**Institute of  
Railway  
Technology**

Report No: Monash/RT/2018/1374 (Final)

**SUMMARY OF REVIEW OF THE ARTC PROPOSED  
UPGRADE PLAN TO ACHIEVE V/LINE PASSENGER  
CLASS 2 TRACK GEOMETRY ON THE VICTORIAN  
NORTH EAST RAIL LINE**

FIGURE 2: INSTRUMENTED REVENUE VEHICLE DATA (RIDE COMFORT) OVERLAYED AGAINST ARTC MUD HOLE LOCATIONS AND TMS500 PEAK LOCATIONS (EAST TRACK).

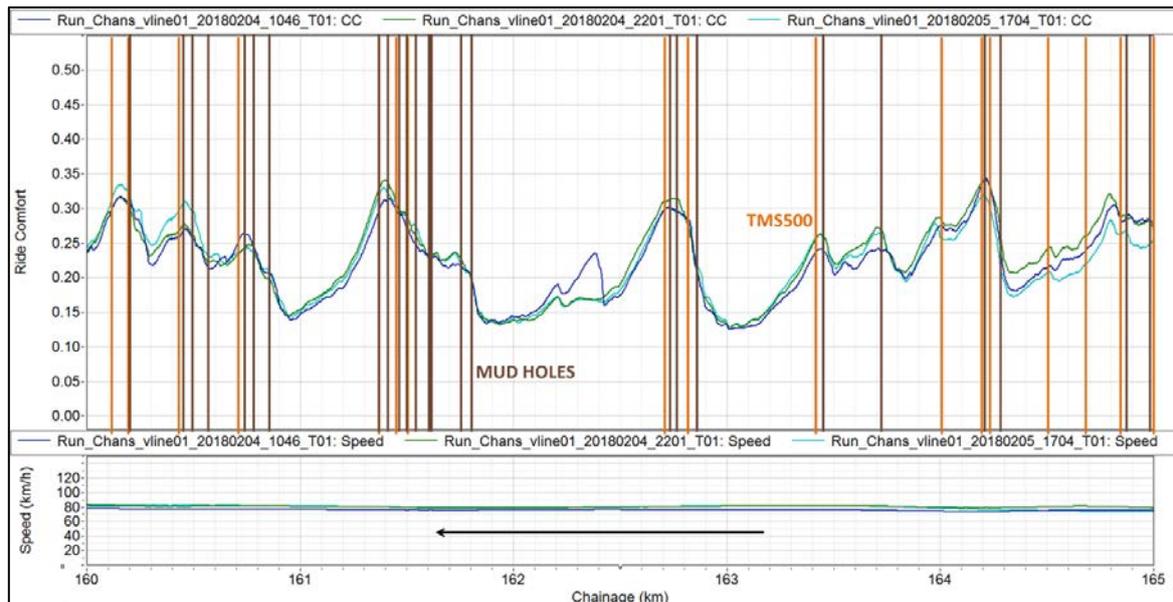
An important criteria in determining upgrade priorities is the assessment of track condition. ARTC focus of the Top Moving Sum as the primary parameter to assess track condition. Additional information is also available including the Victorian Quality Index (VQI), VTI hits as well as passenger ride data from V/Line's Instrumented Revenue Vehicles (IRV). Whilst these multiple parameters exist, the findings of the study indicate that whilst each of the parameters has pros and cons, in general, all of these parameters identify similar track locations as being poor. Figure 2 shows an example of this measured data with an overlay of TMS, vehicle ride and mud hole locations, showing the high level of correlation between each.

All data indicates that the focus on mud hole removal must be a high priority, as there is a very high correlation with poor ride and high TMS levels.
